OYSTER CREEK NUCLEAR GENERATING STATION, UNIT NO. 1

Amendment No. 30
License No. DPR-16

ATTACHMENT TO LICENSE AMENDMENT NO. 30

SAFETY EVALUATION BY THE OFFICE OF NUCLEAR REACTOR REGULATION
SUPPORTING AMENDMENT NO. 30 TO PROVISIONAL OPERATING LICENSE NO. DPR-16
JERSEY CENTRAL POWER AND LIGHT COMPANY
OYSTER CREEK NUCLEAR GENERATING STATION
DOCKET NO. 50-219

FIGURE 3.10.1

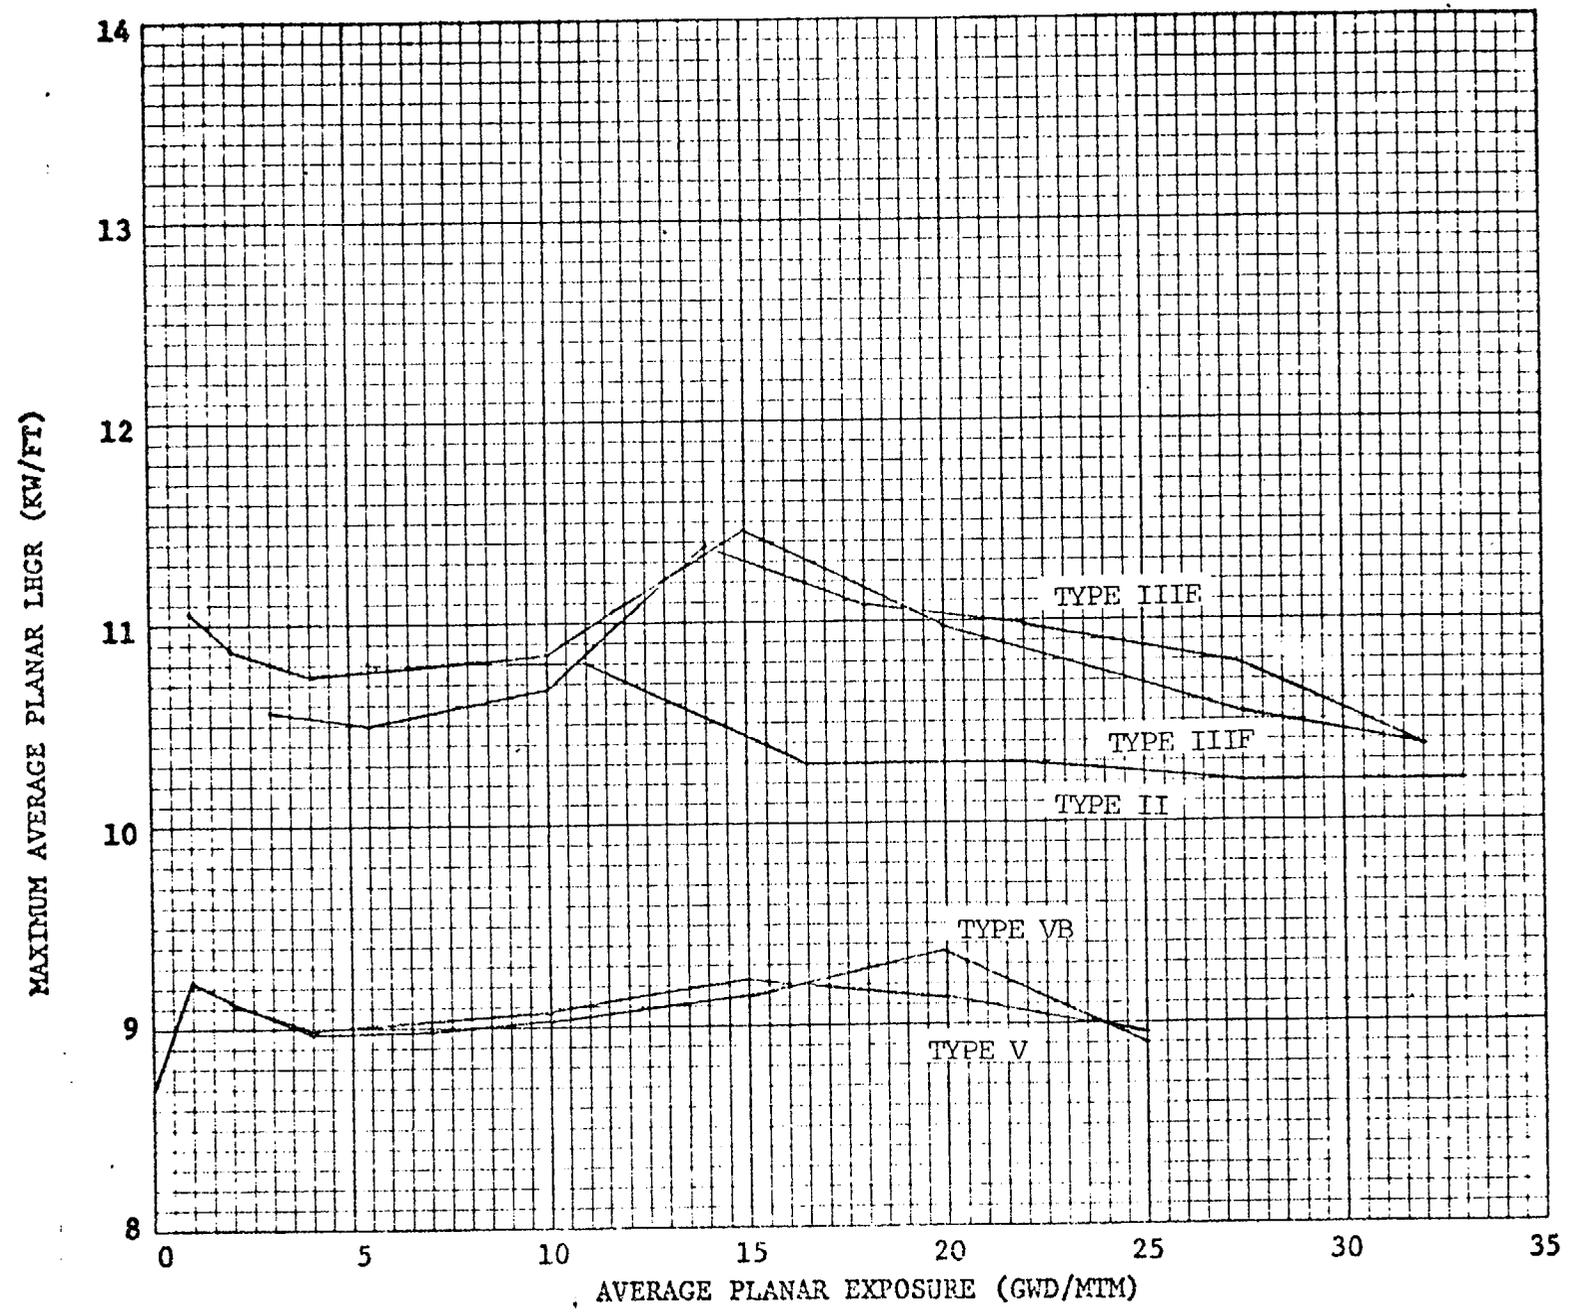
The proposed amendment would extend the MAPLHGR specification for fuel types currently in the core by modifying Figure 3.10.1. This modification extends the calculated MAPLHGR from 27.5 GWD/MTM (thousand megawatt days/metric ton) to 32 GWD/MTM for fuel types III E and III F, and from 20 GWD/MTM to 25 GWD/MTM for fuel types V and V B. The calculated MAPLHGR for fuel type II is not changed.

The proposed extensions of MAPLHGR shown in Figure 3.10-1 are based on an analysis using an approved ECCS evaluation model in agreement with Appendix K to 10 CFR Part 50. This analysis, performed by

We have reviewed the proposed changes and have concluded that they are based on calculation methods previously accepted; they do not change MAPLHGR limits previously found acceptable but only extend the previous calculations to higher fuel exposures and therefore are acceptable.
